Chapter: TRAN – Transport

Feed-back No.	Section	Sub-section	Plan Provision	Feedback	Relief sought
143.32	TRAN – Transport	General		<p><i>Transport</i></p> <ul style="list-style-type: none"> · <i>Safe, efficient and integrated transport infrastructure is provided for and adverse effects of and on this infrastructure is avoided, remedied and mitigated.</i> · <i>Active transport and public transport modes are encouraged alongside efficient transport infrastructure use (existing and proposed).</i> · <i>Methods include a permitted activity regime for maintenance and operation of existing networks, and regimes for crossings, manoeuvring space and parking areas under rules TRAN-R1 to TRAN-R7. There are a number of design and operational standards for permitted activities to comply with, including macro design and micro design matters.</i> <p><i>Transport</i></p> <ul style="list-style-type: none"> · <i>██████████ acknowledge the Draft Plan does not include minimum parking requirements, with the rules and standards relating to performance matters for when access, manoeuvring and parking spaces are provided. The use of these types of standards is supported generally.</i> · <i>However, the r

Figure 15 - Design of vehicle crossings without shoulder widening

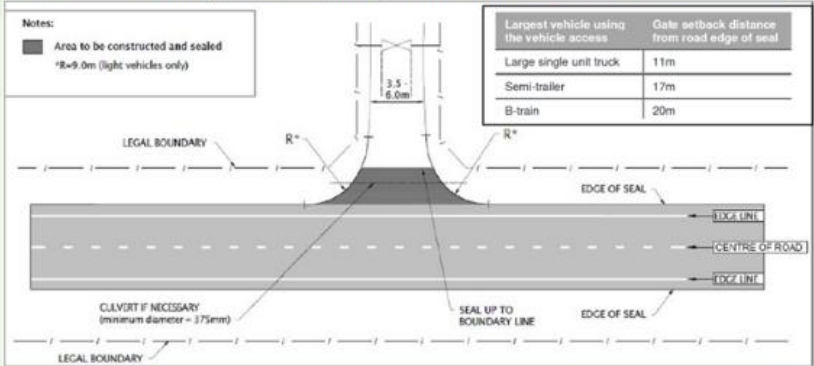
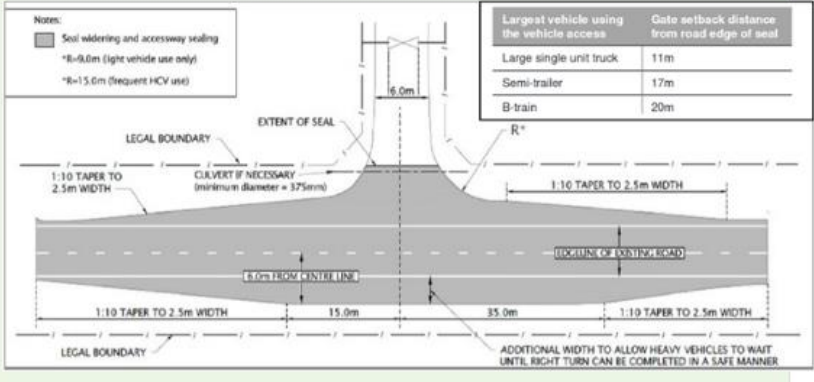
2. Table 17, row b. reads that a vehicle crossing to the State Highway that has 1-30 vehicle movements per day needs to meet Figure 14(17), which is equivalent to the NZTA Diagram E vehicle crossing design in the PPM. However, the PPM only applies this vehicle crossing design for 30-100 vehicle movements per day. It is recommended that row b. is amalgamated with row a. and state yes or no when asking if the vehicle crossing is on a State Highway. Given the merging of the two sections Council should also consider whether it is necessary to ask whether the vehicle crossing is on a state highway or if that column should be deleted.

For the purposes of the Draft Plan we would be open to discussing the option of whether the reference to a Diagram D (or Figure 16) access is removed. On the basis that one heavy vehicle movement is equivalent to 10 car movements this would have the effect that even minor use of a Diagram C (Figure 15 access) by a heavy vehicle would likely trigger the need for an upgrade of access or alternatively a resource consent to allow a suitable design, which might include the option of a Diagram D access (Figure 16).

These designs are reflected in Figures 15 (Diagram C), 16 (Diagram D) and 17 (Diagram E).

It is noted that Table 17 in the Draft Plan does not match the Figure numbers in the Plan and this should be corrected.

1. Table 17 is amended so that it refers to Figures 15, 16 & 17.

Heavy Vehicle movements per week	Volume of traffic using the vehicle crossing per day	Is the vehicle crossing on a state highway?	Which figure to use for vehicle crossing design
a.	≤ 1	1-30	Yes or No	15
b.	≤ 1	31-100	Yes or No	17
c.	> 1	1-30	No	16
e.	> 1	31-100	Yes or No	17

Figure 16 - Design of special use vehicle crossings

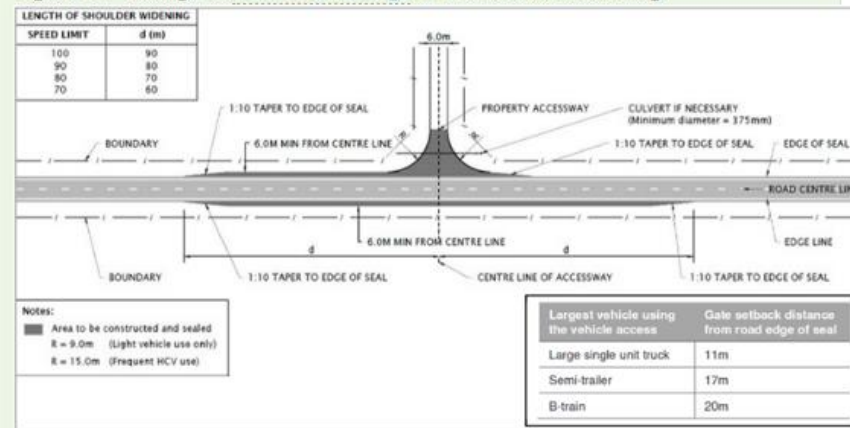
onto a State Highway or local road with more than 1 heavy vehicle movement per week shall be upgraded to Figure 13(16), which is equivalent to the NZTA Diagram D vehicle crossing design in the PPM. [redacted] is currently reviewing the PPM and whether the requirement for a Diagram D access remains appropriate.

Further consideration also needs to be given to the implications of this rule. At this time, it appears that the Figure 16 design (Diagram D) could be applied in inappropriate situations and also any access
